Amendments to the Drawings

Attachment: Replacement Sheet FIGS. 4(A)-4(D).
 Replacement Sheet FIGS. 5(A)-5(D).
 Replacement Sheet FIGS. 15(A)-15(B).

FIG. 4(A)

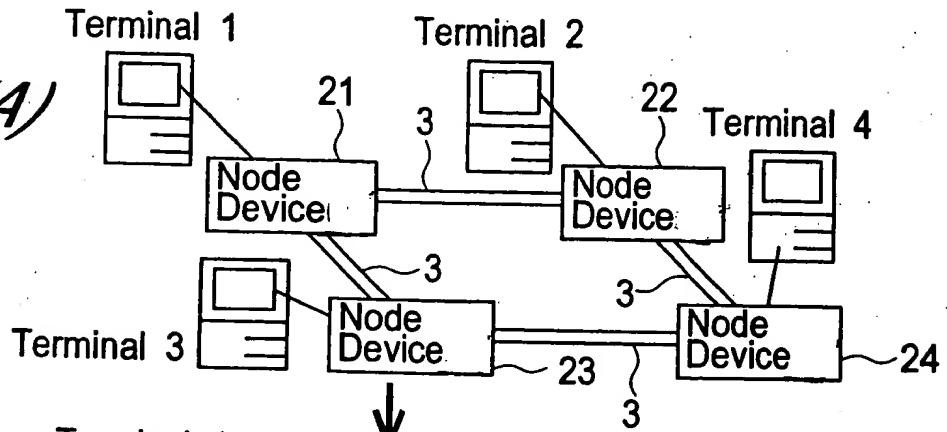
The attached sheet of drawings includes changes to FIGS. 4(A)-4(D), 5(A)-5(D), and 15(B). The attached sheets, which include FIGS. 4(A)-4(D), 5(A)-5(D), and 15(A)-15(B), replace the original sheets including FIGS. 4(A)-4(D), 5(A)-5(D), and 15(A)-15(B). In FIGS. 4(A)-4(D) and 5(A)-5(D), the nodes 21, 22, 23, and 24 are no longer identified as Node Devices (1)-(4), respectively. In FIG. 15(B), optical path D has been changed to optical path E to agree with the specification (see page 20).
